Bramford to Twinstead Reinforcement

**Document 8.9.5 (C): Temporary and Permanent Access Technical Note
– Suffolk County Council**

**Final Issue C
February 2024**

Drawing title: **F-DAP4: The Street, Assington
 Proposed Visibility Splay
 Concept Design
 Sheet 1 of 1**

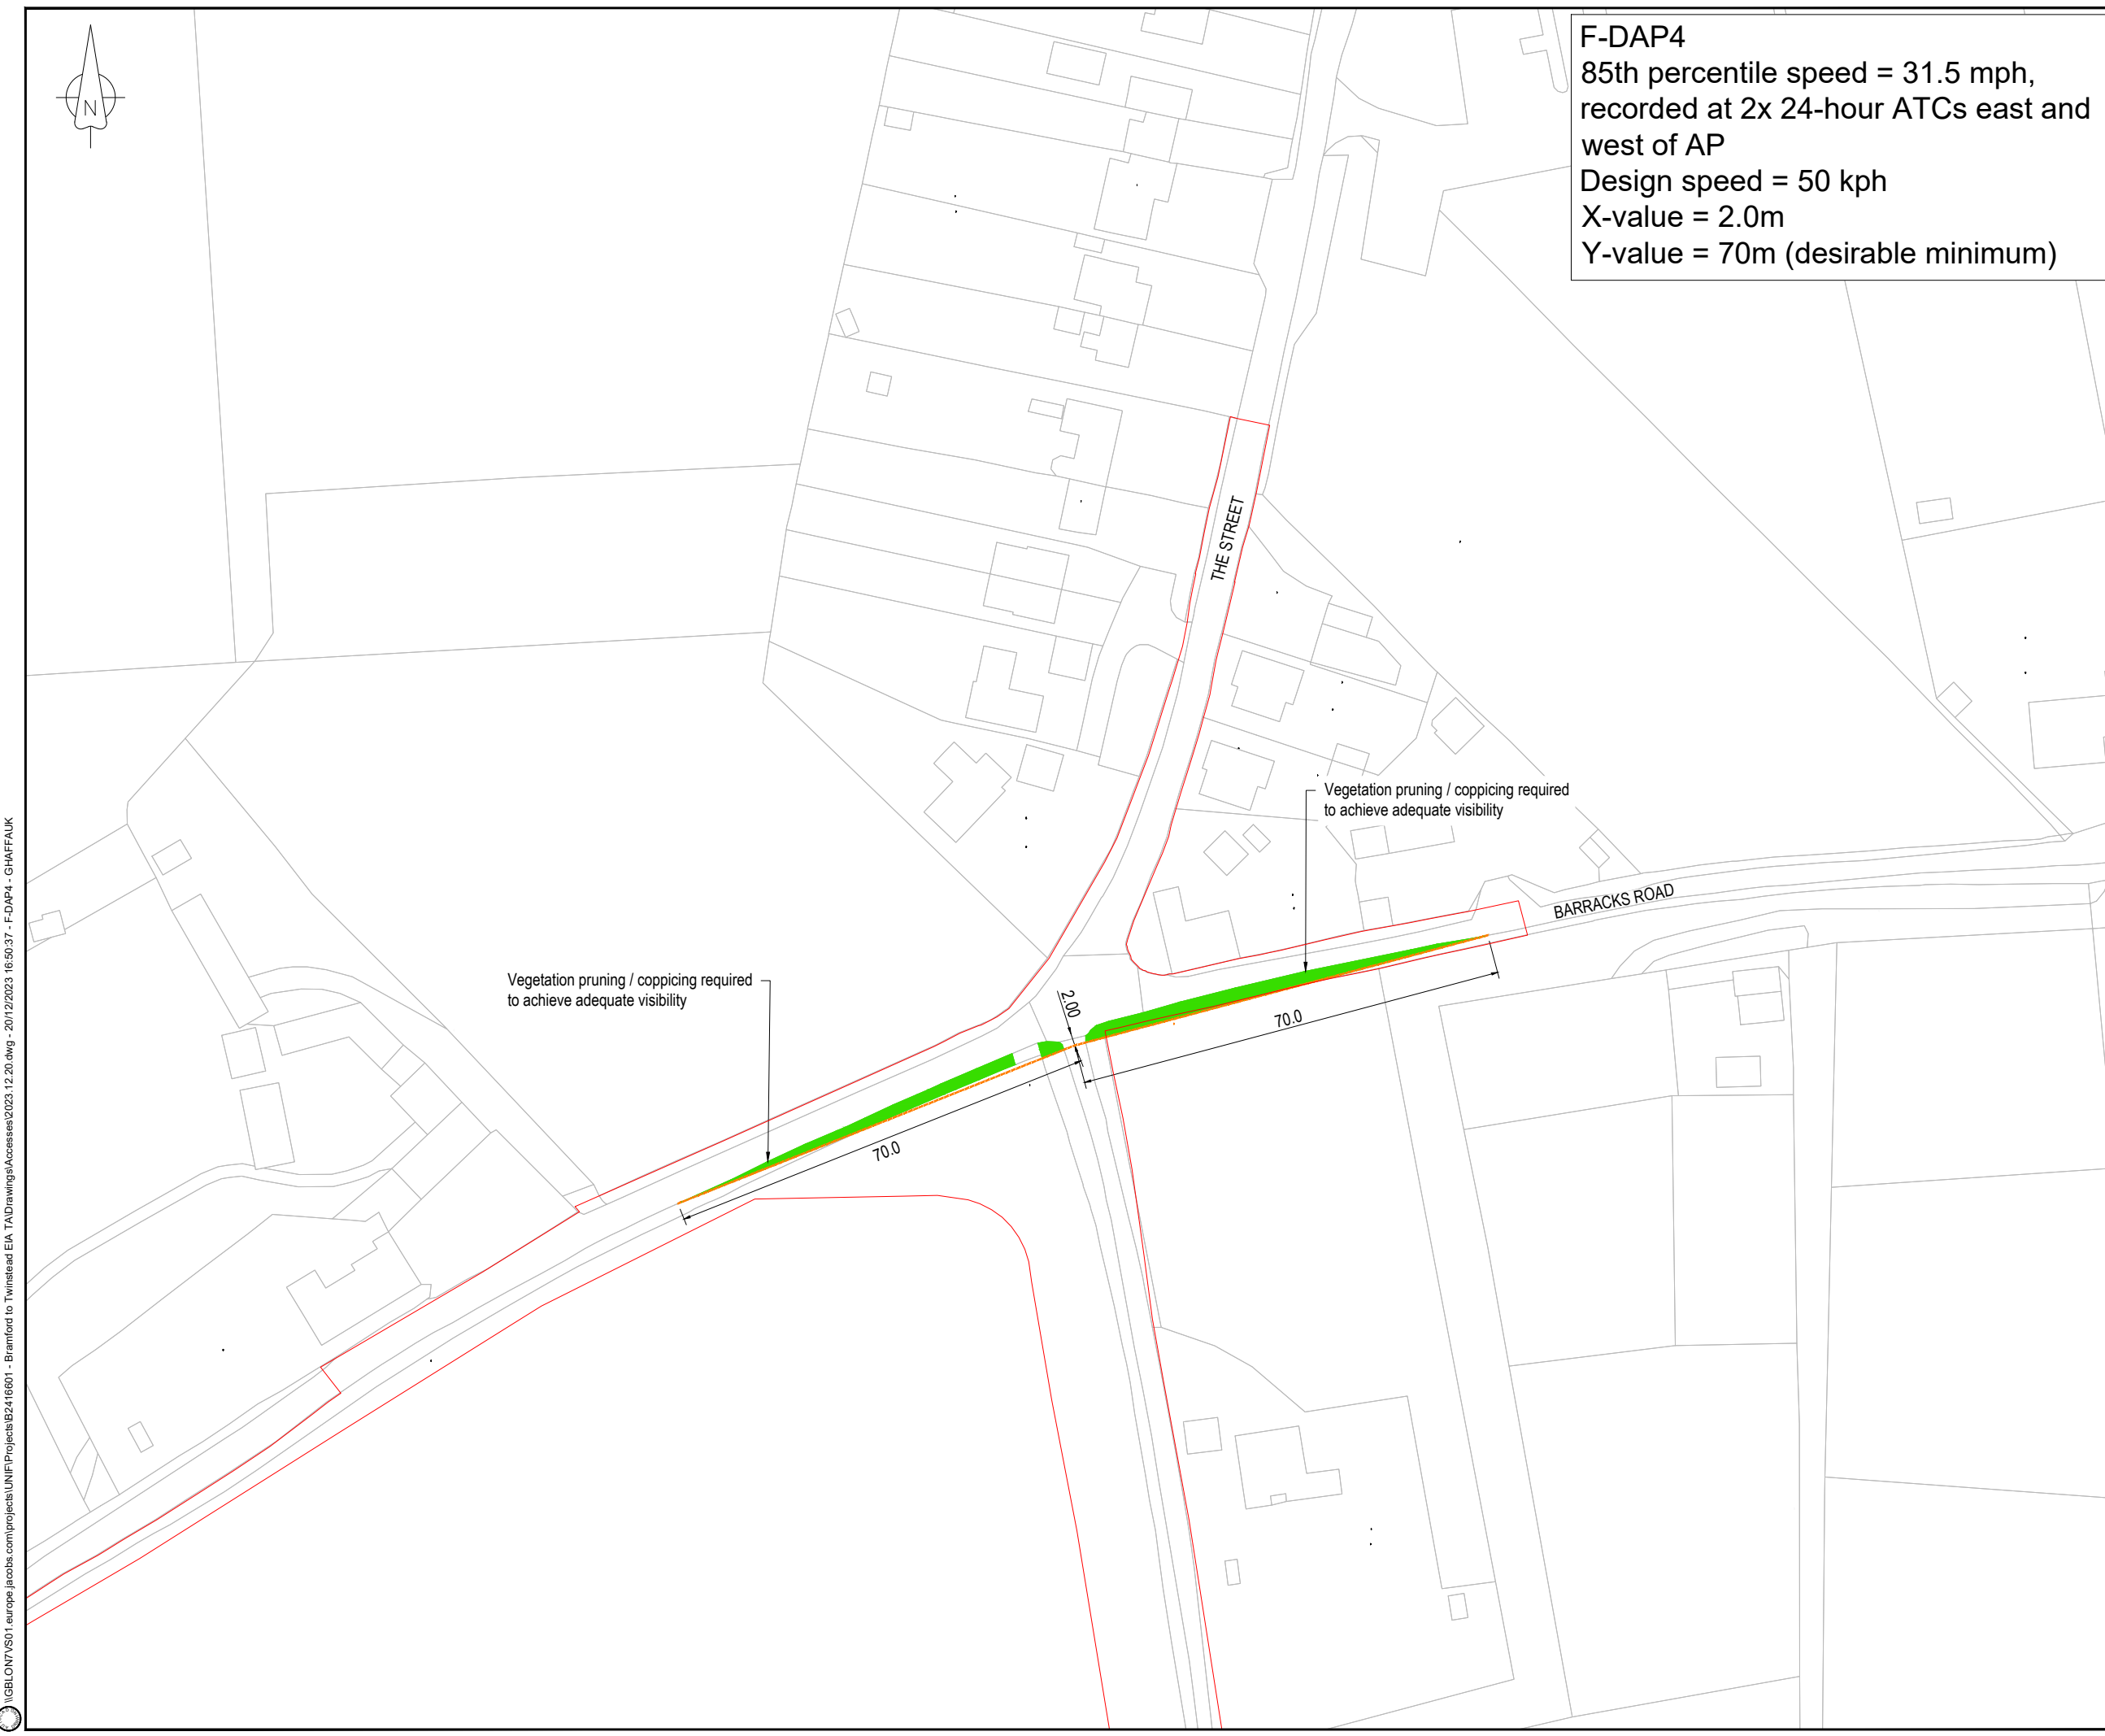
- 2.9.4 Beyond this hedge there is further vegetation along Barracks Road, which grown to the carriageway edge which would require pruning to achieve the required sightlines. The Applicant does not see this minor pruning as an impediment to the safe provision of access at this location given the powers available in Article 48 of the draft DCO [**REP-003**]. In addition, Requirement 8 of the draft DCO requires the approval of all vegetation to be agreed by the relevant planning authority prior to construction work commencing.

Drawing title
**F-AP4: B1068 Stoke Road, Leavenheat
 Proposed Visibility Splay
 Concept Design
 Sheet 1 of 1**

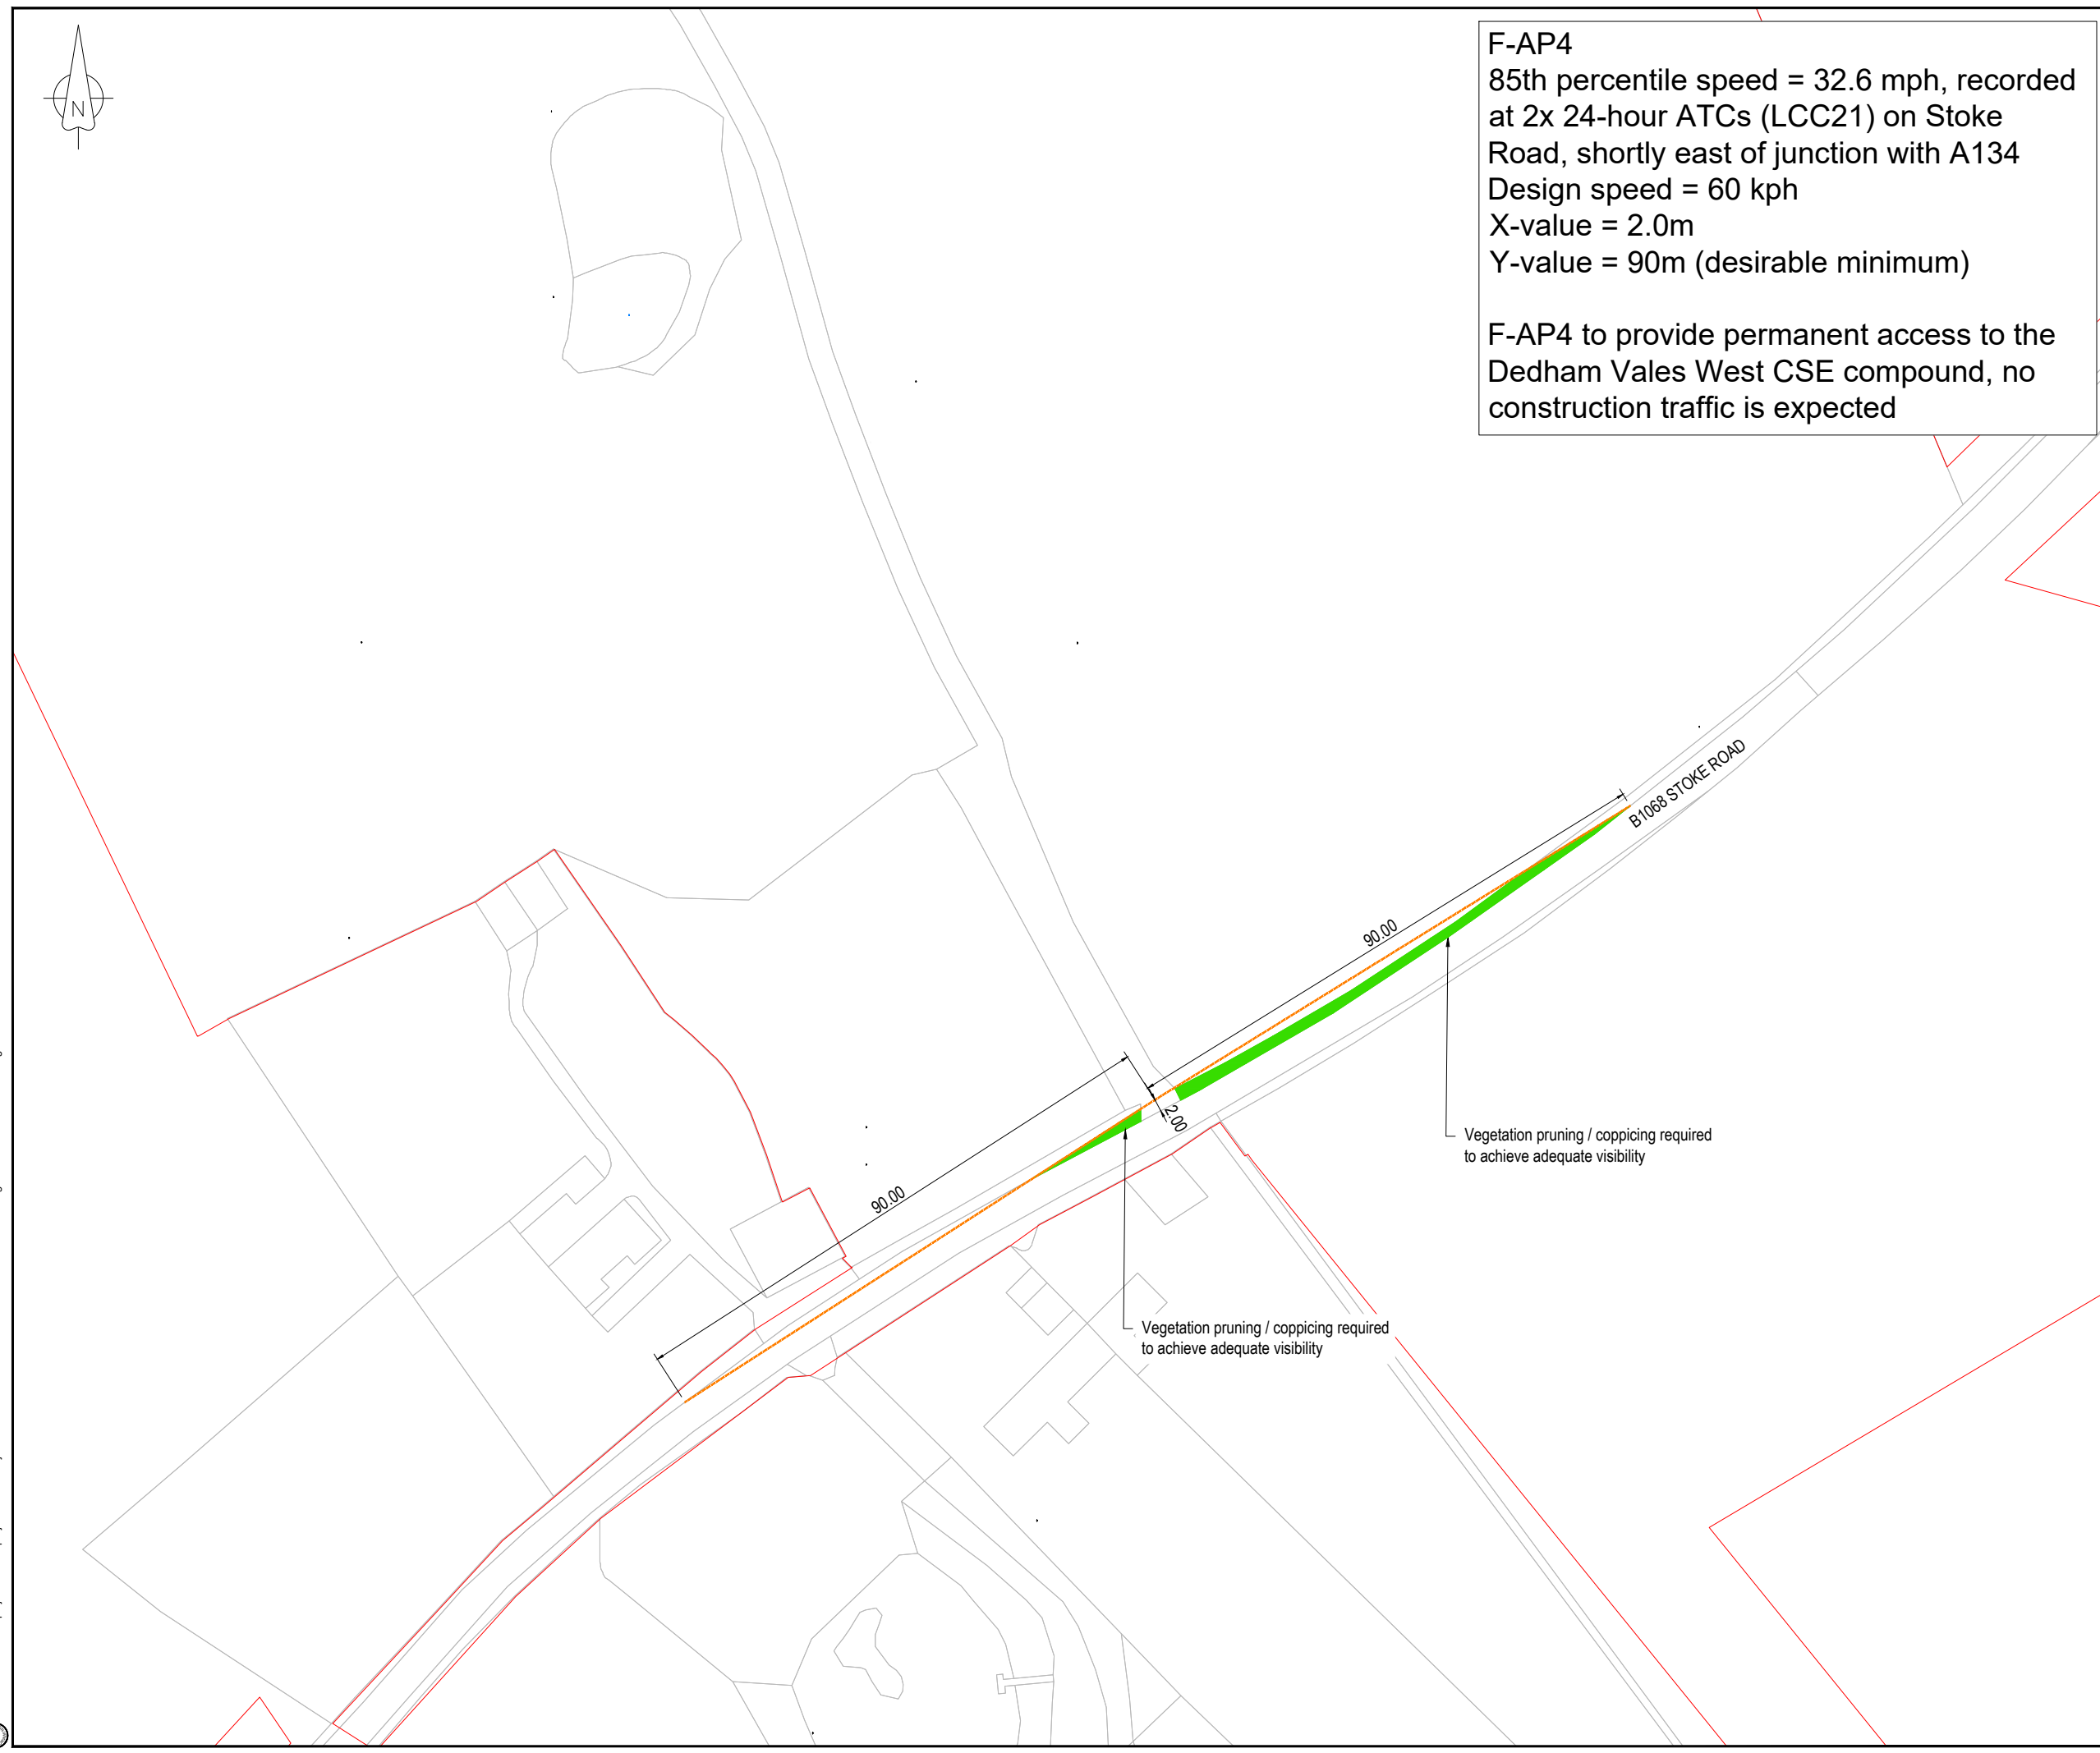
- 2.11.1 F-AP4 (Stoke Road, Leavenheath) is shown on sheet 15 of 30 on the Access Rights of Way and Public Rights of Navigation Plans [APP-012] and in Appendix A of this Technical Note. The access F-AP4 is intended to provide permanent access to the Dedham Vale West CSE compound and no construction traffic is expected.
- 2.11.2 In normal operation, only one vehicle a month is expected at the compound. During maintenance periods, up to four vehicles a day for three weeks per circuit every eight years are expected to use the access.

- 2.11.6 Any vegetation removal would be part of the submitted package of approvals for LHA approval before the project progressed to construction in accordance with Article 48 of the draft DCO (~~document 3.1 (G)(H)~~). In addition, Requirement 8 of the draft DCO requires the approval of all vegetation to be agreed by the relevant planning authority prior to construction work commencing.
